From: Chris Keenan <chriskeenan@charter.net>
Sent: Wednesday, April 09, 2014 12:16 PM
To: 'J Zimmer'; pcc@cs.wpi.edu
Cc: 'Mendez, Ronald'
Subject: RE: 196 West St NOI
Attachments: ATT_Paxton.pdf

**PAXTON, MA
SITE NO.: MA4388
196 WEST STREET
PAXTON, MA 01612**

CONSTRUCTION DRAWINGS

TITLE SHEET

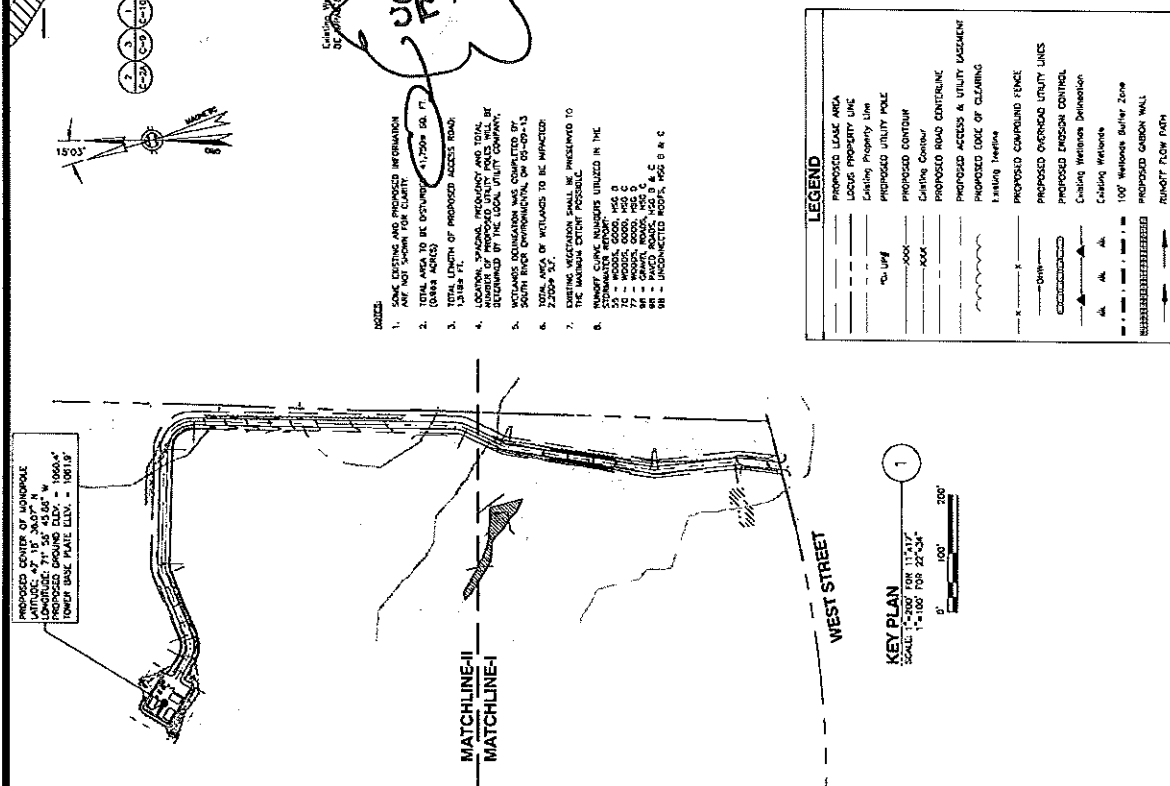
- Add wetland consultant contact information to the Title Sheet, T-1
- Note #3 , Erosion and Sediment Control Plan on Sheet G-1, the first sentence should read "disturbed" and not "undisturbed".

NOO
WETLAND CONSULTANT
+ CONTACT
INFO

STILL NOT RESP.

SHEET TITLE	
WETLAND CROSSING & REPLICATION DETAILS	
SHEET NUMBER

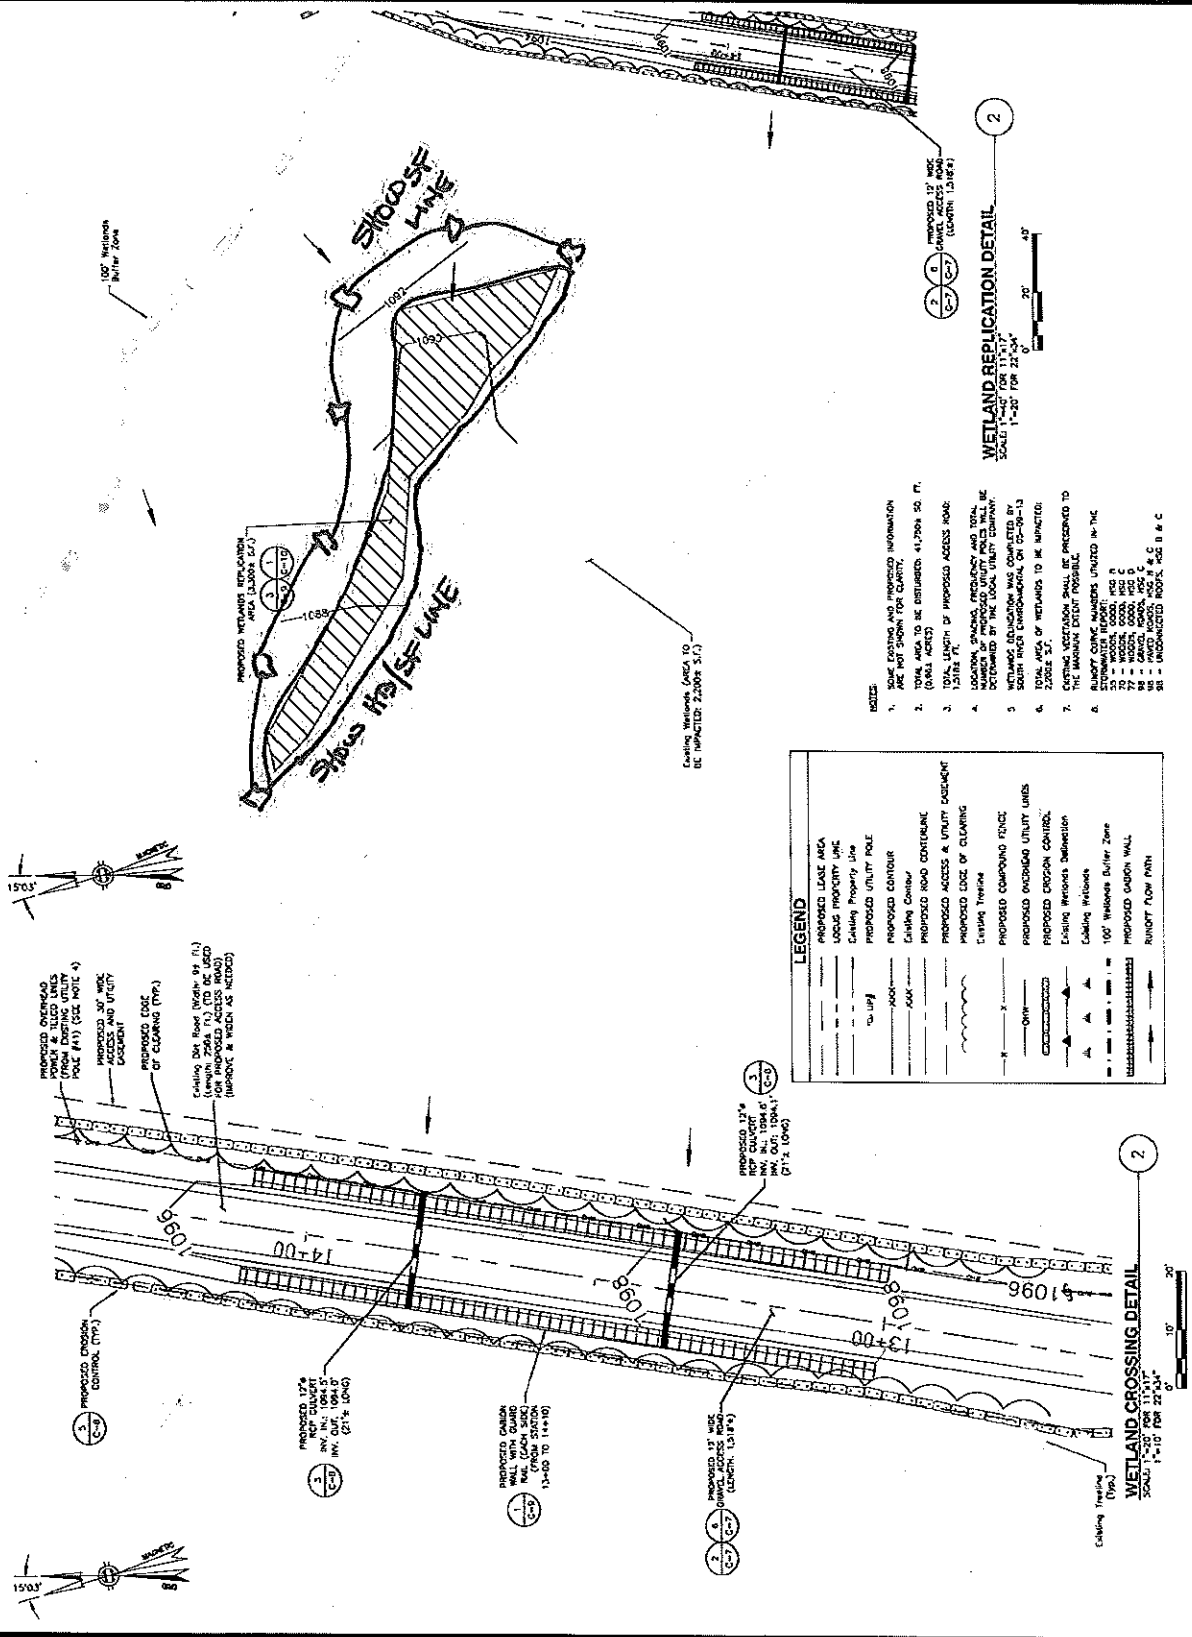
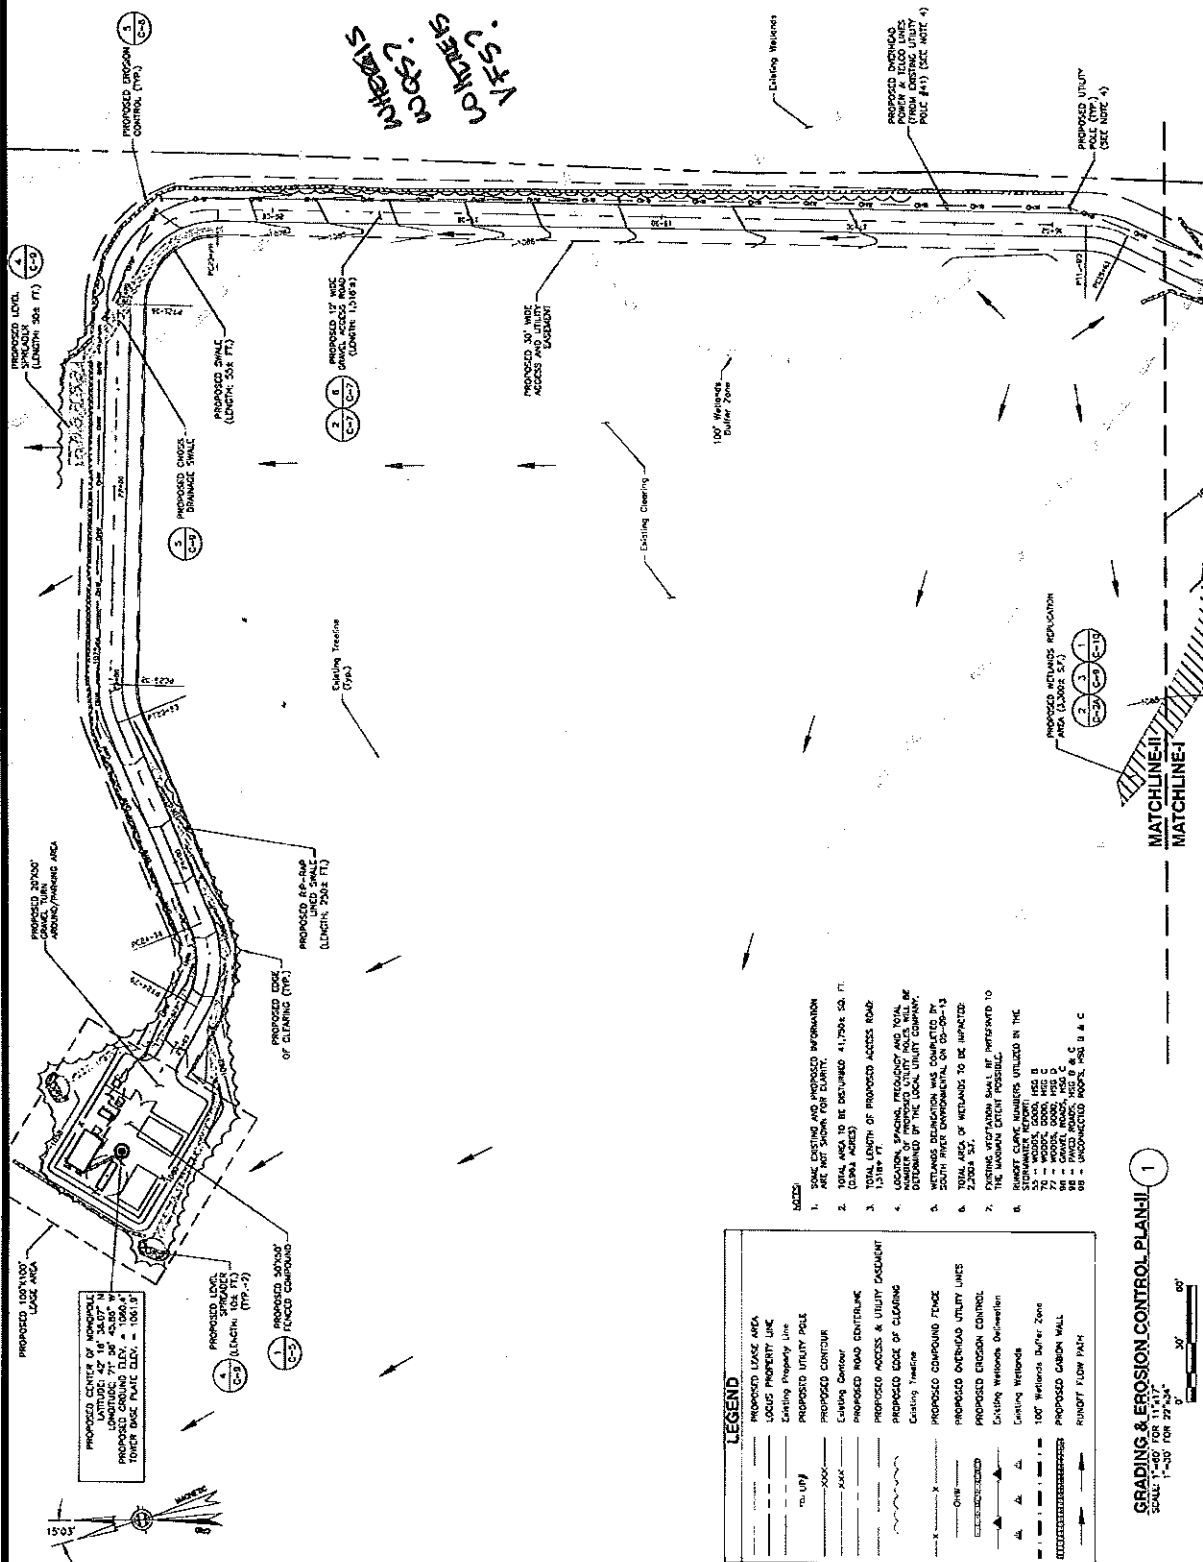
- Add hay bale and silt fence lines to plan view of wetland replication detail on Sheet C-2A.
- Add notes to the silt fence – haybale barrier detail on Sheet C-8. Staked bales are to be weed free straw bales. Installation must be inspected and approved by the Conservation Commission prior to the commencement of any work.

- Note the location of all water quality swales on Sheets C-2, C-2A, and C-3. Or provide a new detail plan of specific areas.
- Note the location of all vegetated filter strips on Sheets C-2, C-2A, and C-3. Or provide a new detail plan of specific areas.

ROAD CROSS SECTION WITH SWALES
(STA. 12+75 TO 14+50) (STA. 23+00 TO 25+18)
SCALE N.T.S.

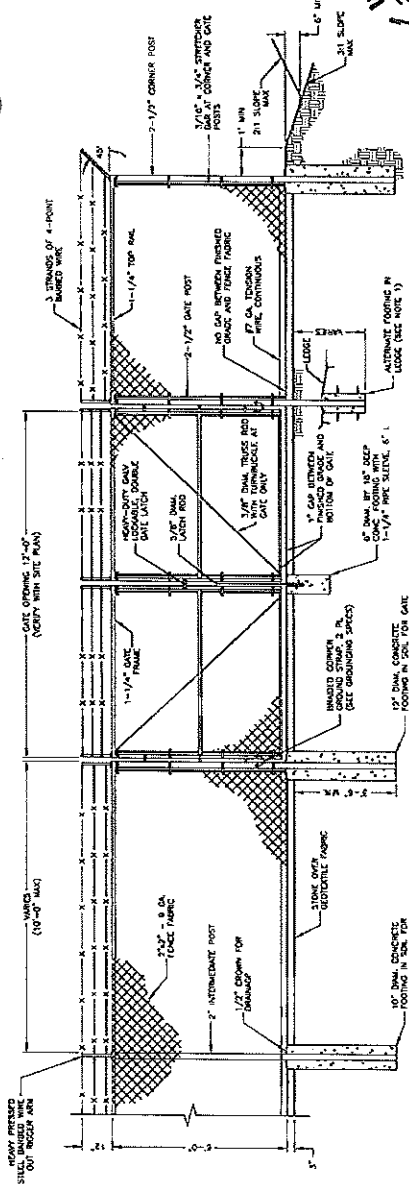
- b. The stormwater report claims 45% for a 50' wide or greater vegetated filter strip. Show the filter strip(s) on the plan acting as pretreatment for the water quality swales. From the plan detail Road Cross Section With Swales, Sheet C-7 it appears that stormwater originating from the proposed gravel driveway does not flow through 50' of vegetation before entering the proposed swales. Swale geometry is not consistent with the requirements of water quality swales.

- Add a 3:1 max slope notation to the slope leading down to the replication area on the wetland replication detail on Sheet C-9.
- Water quality swales are vegetated open channels. The construction details on Sheet C-7 indicate rip rap lined swales. Revise the details to show vegetated swale bottoms and side slopes, and provide a grass planting specification suitable to the soil and water conditions.

- Roadway cross sections on Sheet C-7 appear to show that stormwater originating from the proposed gravel driveway does not flow through 50' of vegetation before entering the proposed swales.

WQS IS
GRAVEL LINED
3:1 MAX SLOPES

VEGETATED
FILLER?
STAIR?

SHEET FILE	
CONSTRUCTION DETAILS-III	
SHEET NUMBER

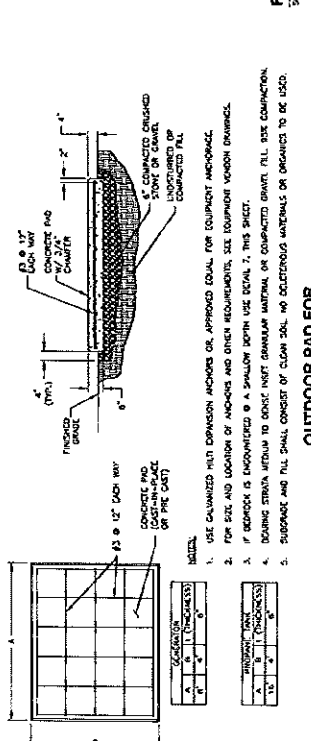
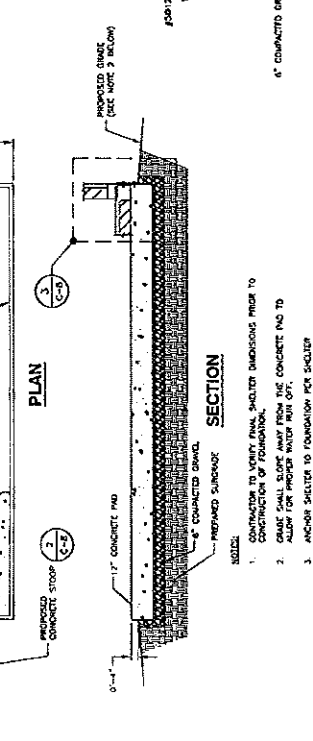
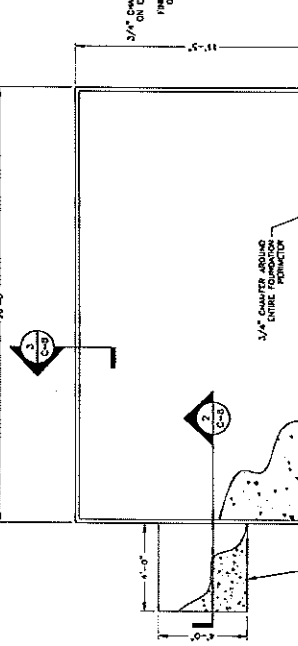
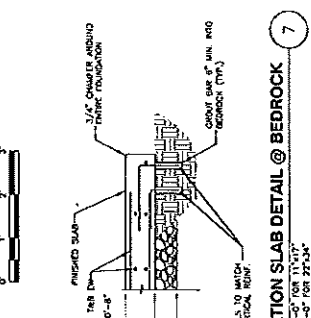
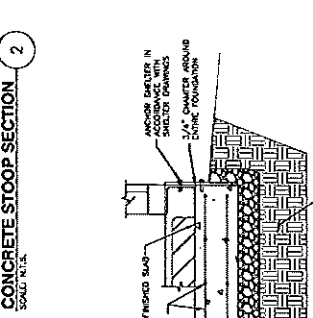
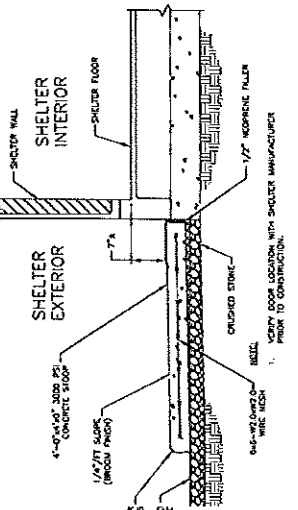
- Add dimensions to the gabion wall section detail on Sheet C-9 from inside edge to inside edge of the guard rails, and outside edge to outside edge of the gabion walls.

- Provide a construction detail for roadway sections STA 0+00 – 10+00.
- The location of the guard rail does not appear to meet current MA DOT standards. Limit the speed on the proposed gravel drive to 10 mph with signage.

(Both ends?)
